Subject: Fwd: Comments on 2025/0384/P have been received by the council.

Re: 2025/0384/P (OBJECTION)

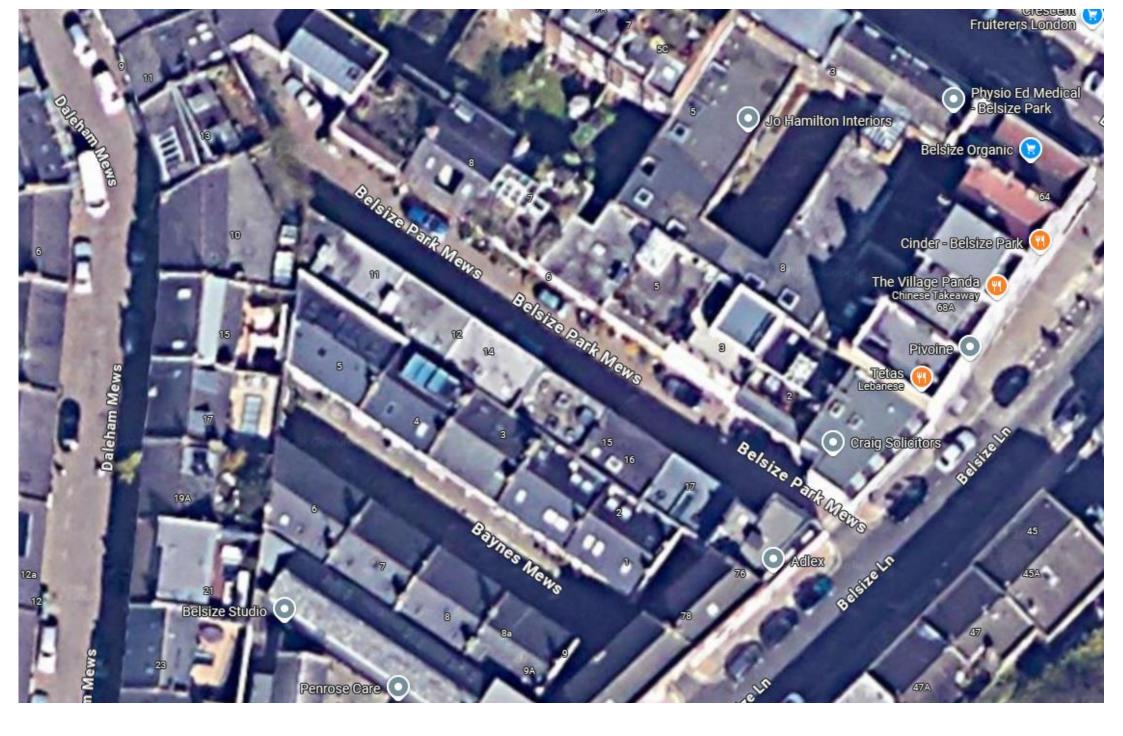
You will note from the attached images that the ground floor of our property is significantly glazed. In keeping with the methodology of sustainable architecture this along with other measures is in order to facilitate the passive heating of our home through the retained heat in the ground floor slab. The operational efficacy of the slab is particularly crucial during the months of January, February, and March when the angle of the sun is at 280, 340 and 420 respectively as the shorter daylight hours and lower solar angles mean the floor is required to work that much harder. It is our contention that the proposed development (should it go ahead as proposed) will drastically and irrecoverably diminish the winter/spring performance of our passive heating system, to the detriment of the normal enjoyment of our property and thus we would ask that any proposed roof level development (at the application property) should be set back significantly from the lines currently proposed.

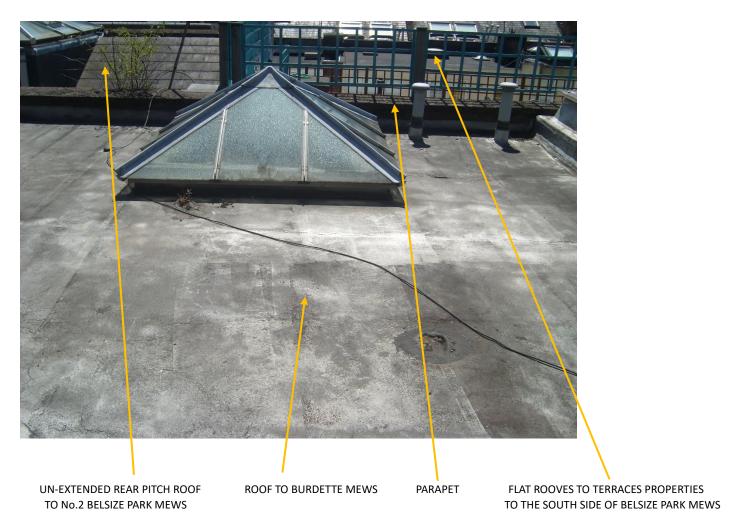
HERE THE ROOF OF LEVEL OF BURDETTE MEWS CAN BE SEEN ALONG WITH THE EXTENT TO WHICH THE ROOF DEVELOPMENTS TO PROPERTIES ON THE NORTHERN SIDE OF BELSIZE PARK MEWS ARE SCREENED BY THE EXISTING PARAPET EXTENSION TO THE REAR PARTY WALL. ALSO NOTED IS THE CURRENT ABSENCE OF ANY ROOF LEVEL DEVELOPMENTS TO THE TERRACE OF PROPERTIES TO THE SOUTHERN SIND OF BELSIZE PARK MEWS
